Environmental Review Team Report

Chittenden Hill Estates

Clinton / Westbrook, Connecticut

October 1978

Preliminary Subdivision Plan

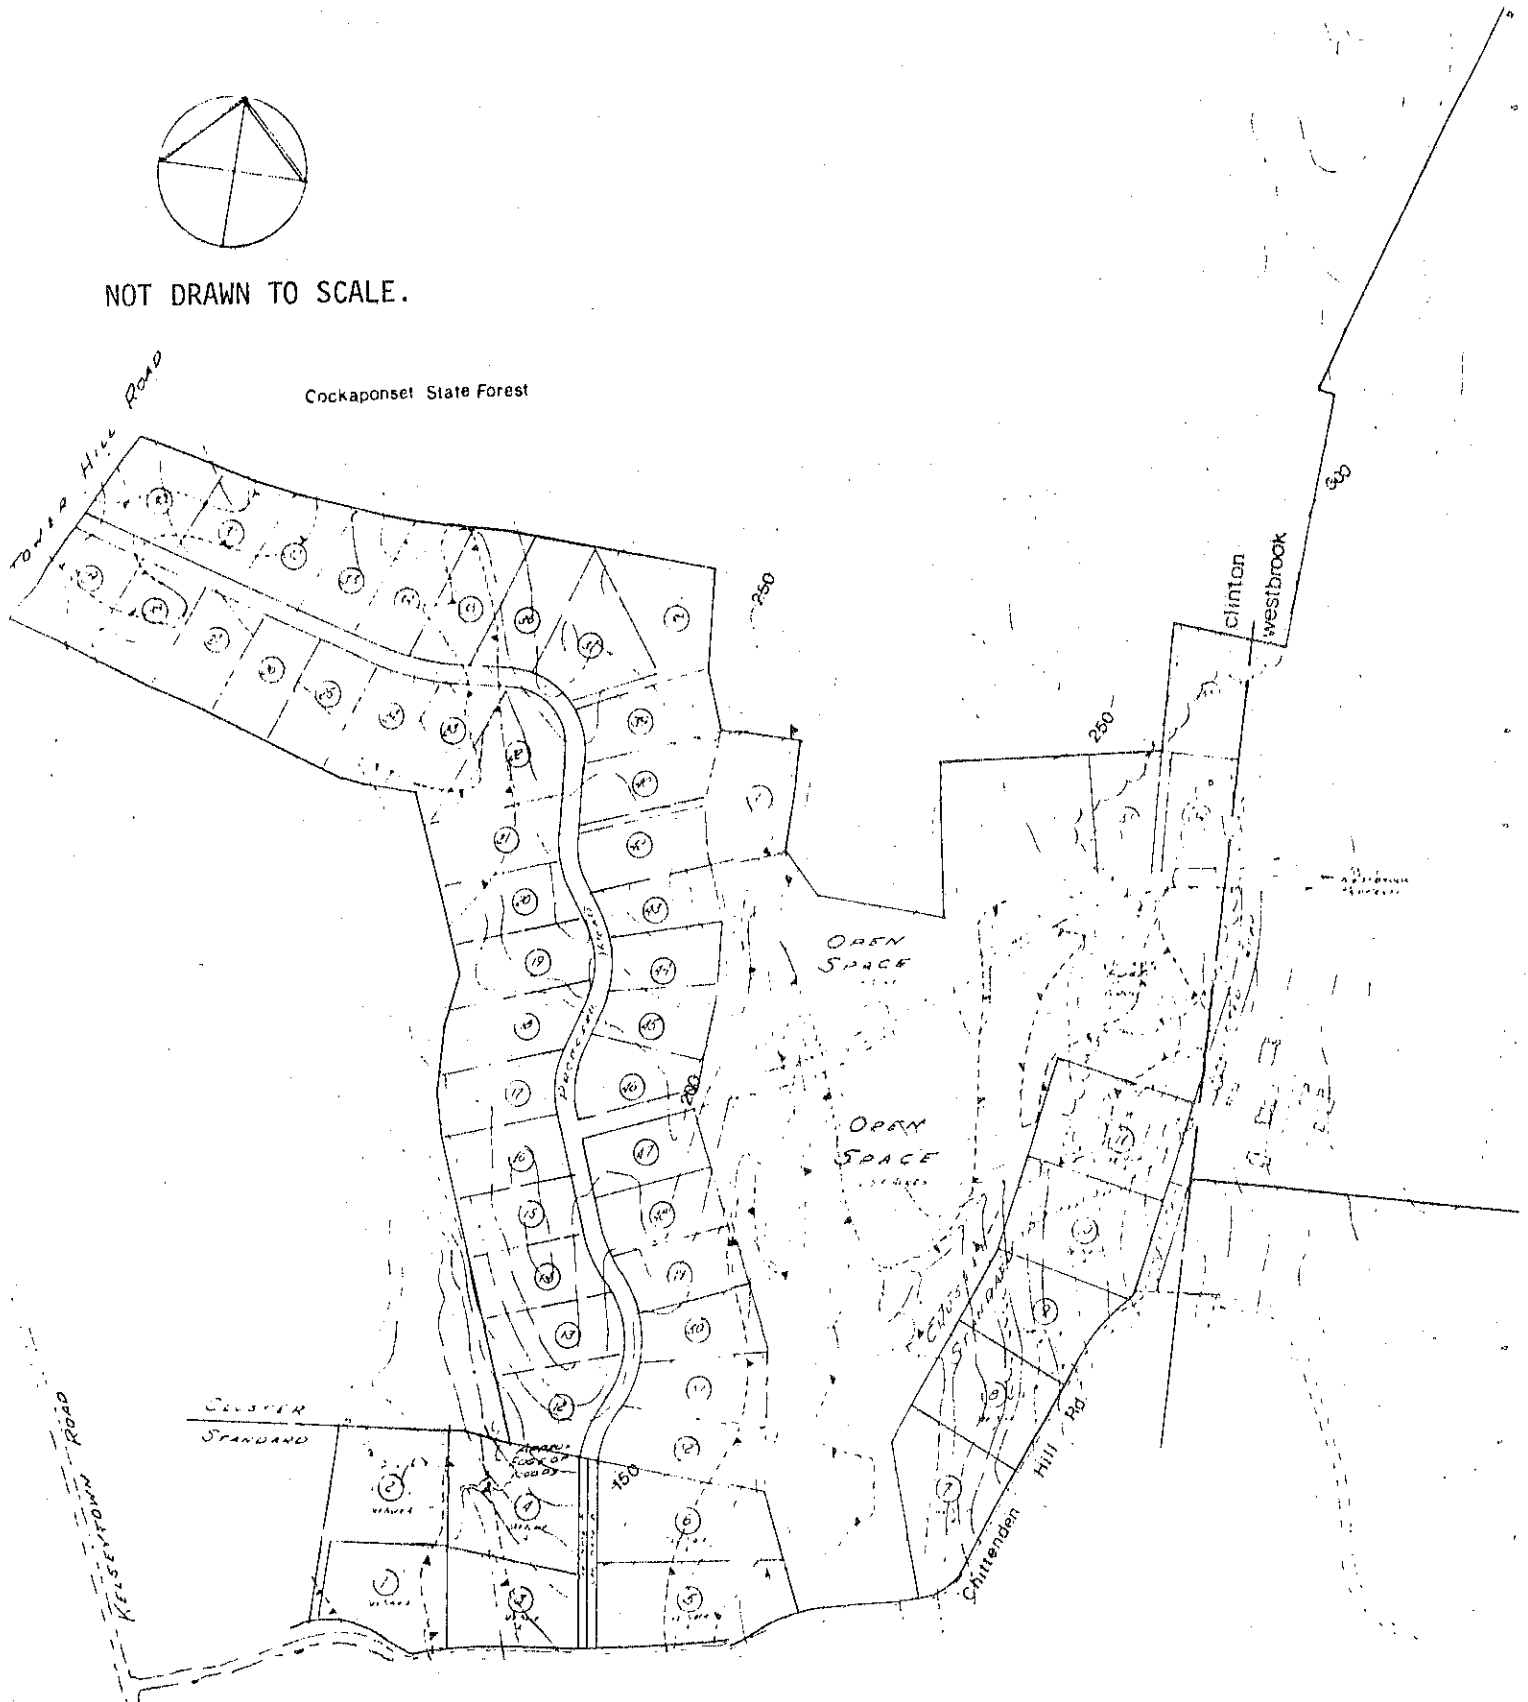
It is suggested that the proposed road not be put through the open space area. This road will effectively isolate the lower 25-acre open space plot, and the loss of continuity between the open space area and the State Forest will lessen the wildlife value and use of the area. Since the road will effectively serve only

three lots (53, 54, 55) initially, its need is questionable. Access to lots 10 and 11 will be provided by upgrading the farm driveway, and this lane can both provide service to lots 53-55 and later be improved to service additional lots on the Westbrook parcel. The right of way between lots 46 and 47 can be used to provide access to the open space area.

The proposed Chittenden Hill Estates subdivision is located in an area with many wetlands and bedrock outcrops. Many of the lots in the northwest corner of the proposed subdivision are located primarily in wetlands. Construction in these fragile areas should be avoided. The area does not appear to be suitable for the typical standard subdivision; hence, a cluster design should be considered as a way of optimum utilization of developable land and preservation of wetland areas. Access roads are also proposed to cross wetlands in the northwest section of the site and the proposed open space area. Consideration should be given to rerouting these roads to avoid these critical areas.

Watershed Areas

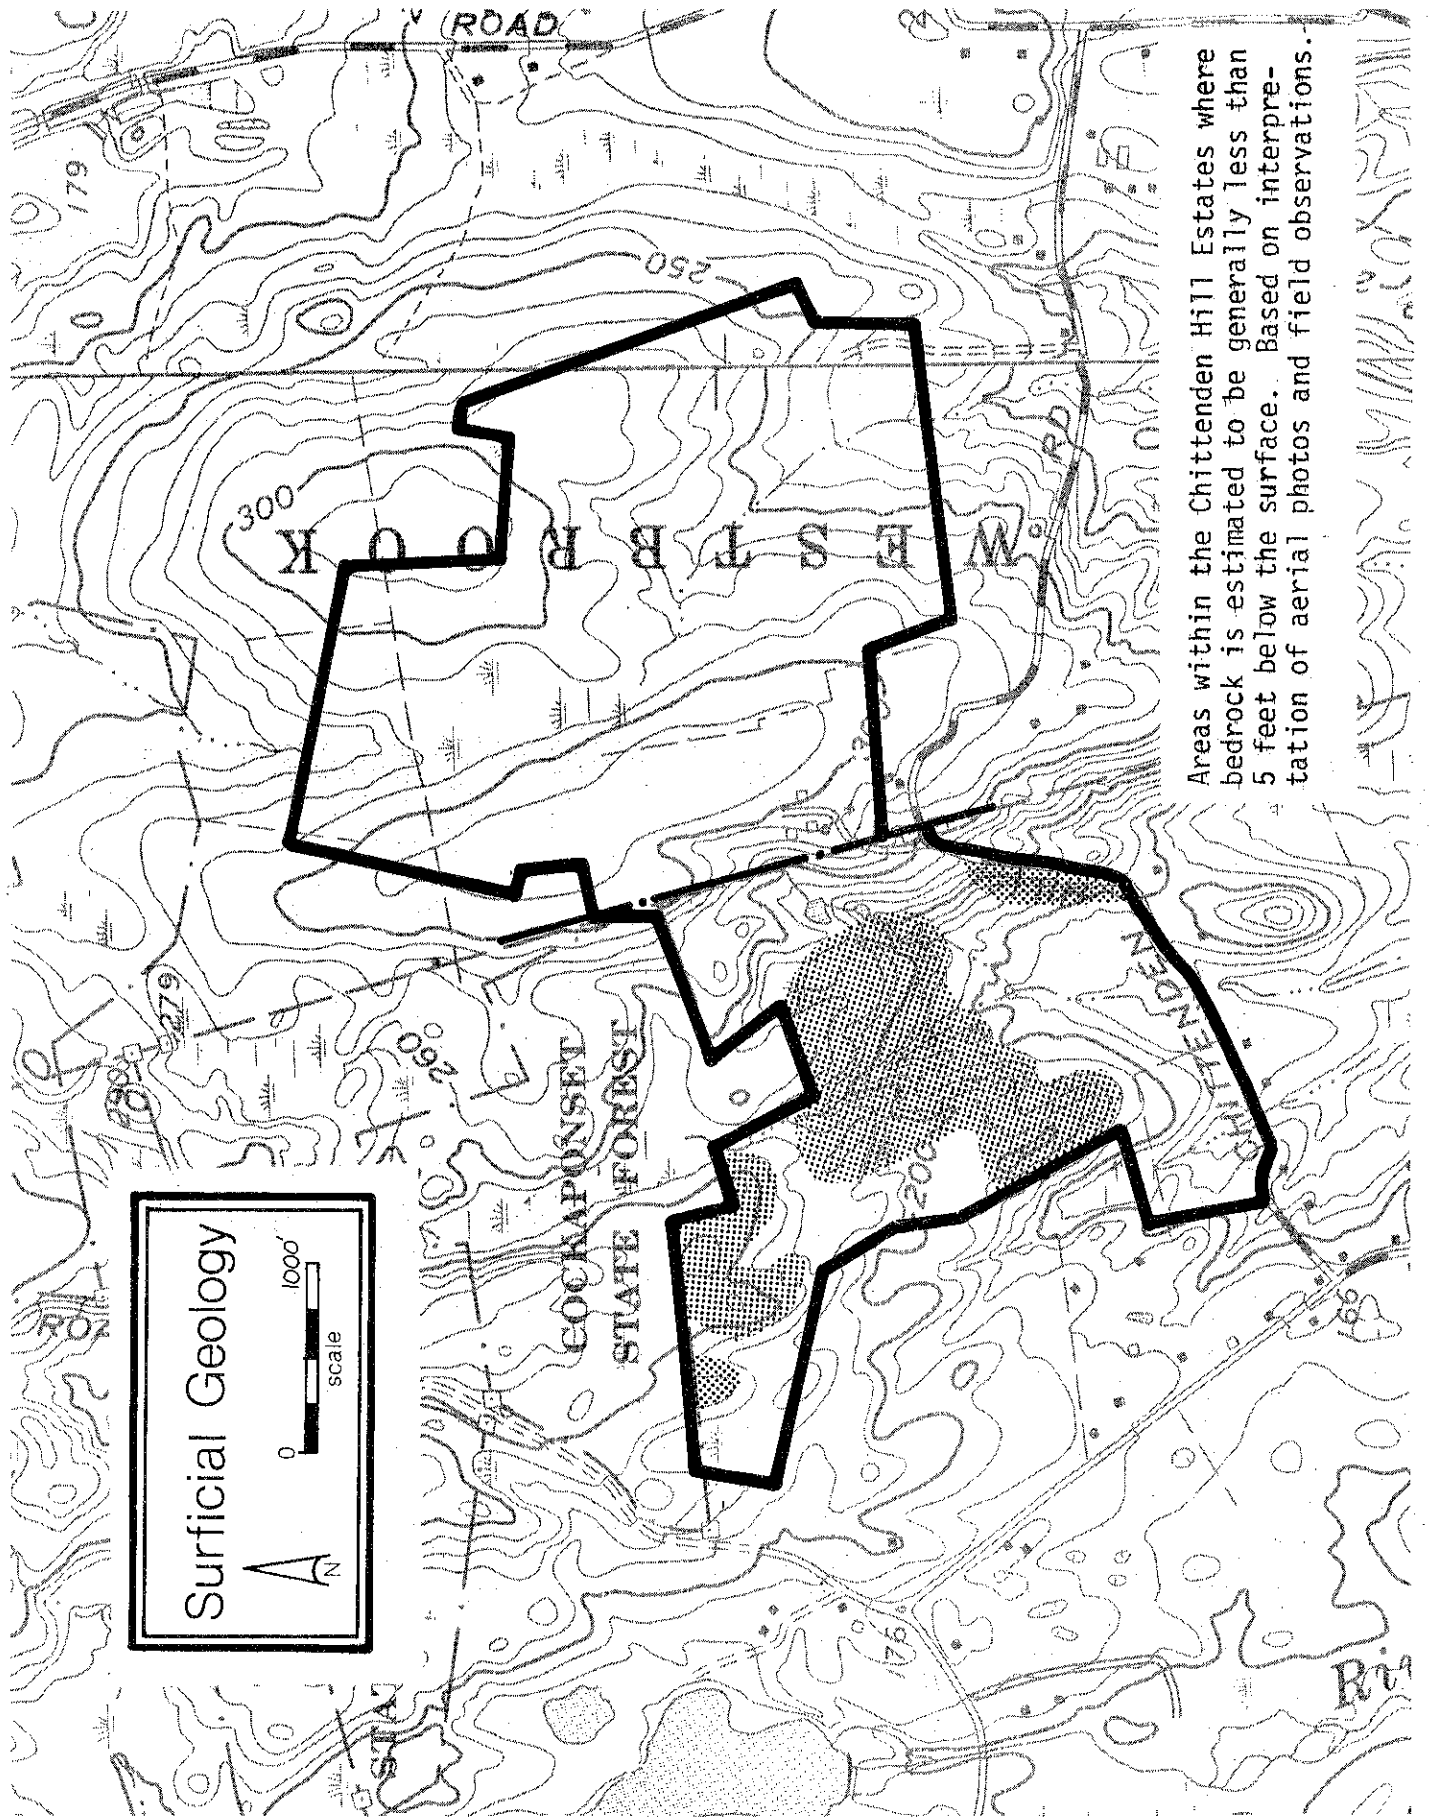
The results of the analysis of the Clinton section are shown in the accompanying table. The volumes shown are based upon 6-hour duration storms of different magnitudes; for instance, the 6-hour, 100-year storm is one of great intensity that occurs on an average basis of once every hundred years, while the 6-hour, 2-year storm is one of lesser magnitude that occurs much more frequently. The estimated increases in runoff volumes are significant, and two important points are demonstrated: (1) the percentage of the increase will be greater for the more frequent storms, and (2) the percentage increases for the watershed as a whole are smaller than the increases that will occur on any individual acre that is developed. The table also shows potential increases in peak flows at the culverts under Chittenden Hill Road. These last values are important because the culverts are both quite small.

The numbers presented in the table are meant only as ballpark guides to runoff increases, and should not be construed as exact engineering data. The estimates themselves are based on incomplete information; they probably are somewhat conservative, as they do not take into account the construction of roads or drainage channels, or the topographic modifications that will be necessary in many areas because of the irregularity of the land. However, the numbers do show the need for special care in designing drainage measures in order to avoid localized erosion, sedimentation, and flooding problems, and for a more thorough evaluation of the culverts under Chittenden Hill Road and their ability to handle future peak flows. Because of the apparent need for cut-and-fill in many areas, the opportunity for sedimentation in the local wetlands will be great without appropriate precautions. The final subdivision plan should include some discussion of the previously outlined hydrologic data.

VEGETATION MAP

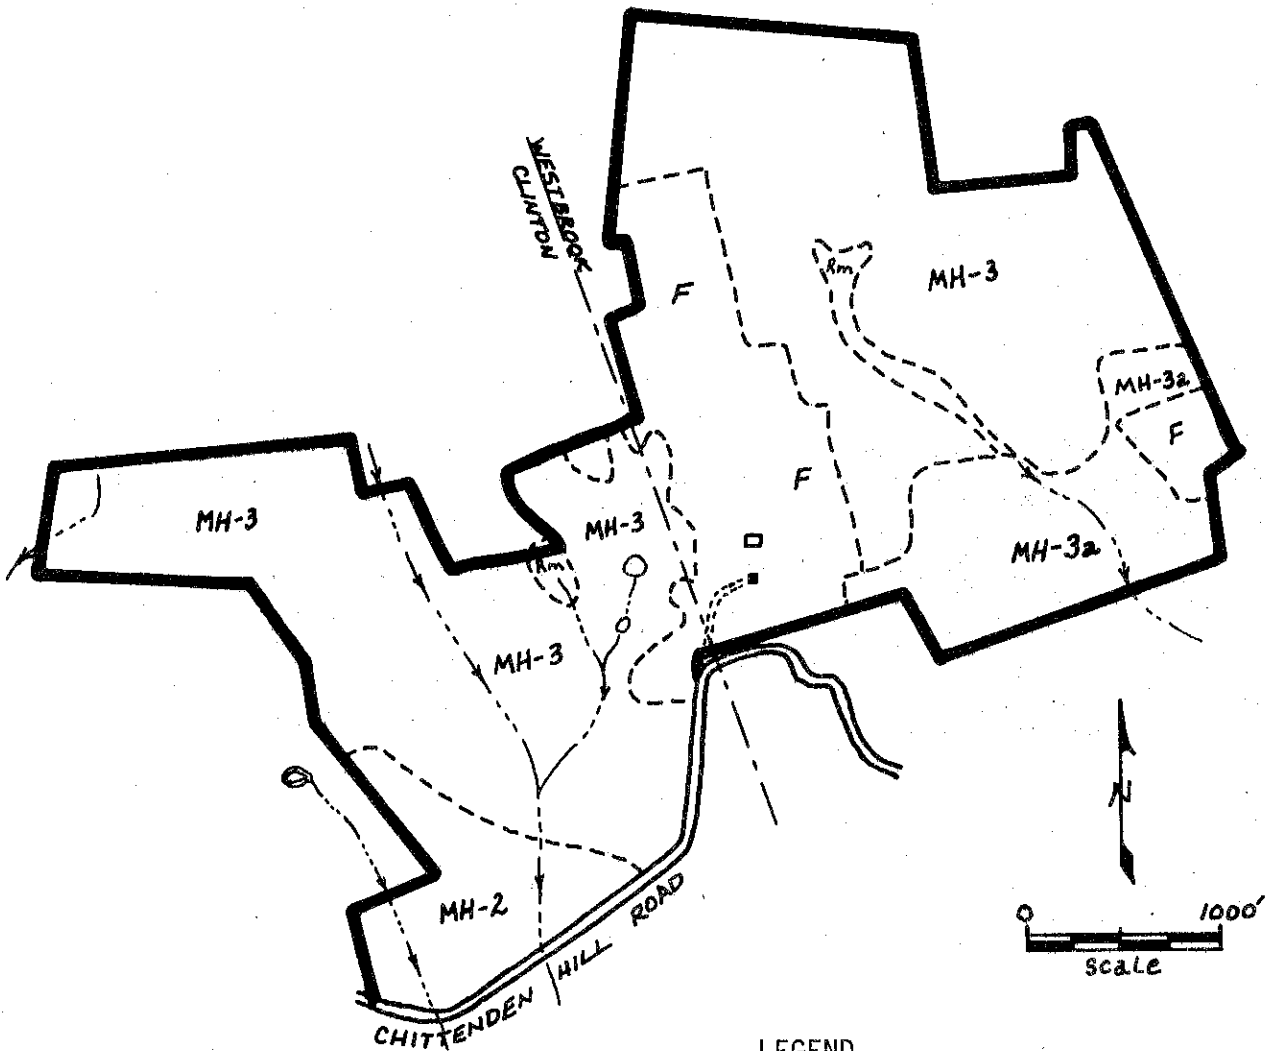
A fragipan exists within 24 inches of the surface in most of the soils on the property. Therefore, trees are probably shallow-rooted and predisposed to blow down. The high density of trees on parts of the site aggravates this condition. In order to reduce this hazard, a thinning of stand density by one third,

to provide more growing space for the largest crowned trees should be conducted several years before house lots are cleared. This would give trees time to extend their root systems and strengthen their trunks before wind corridors are created. A private forester should be retained to mark trees to be cut and supervise the harvest.
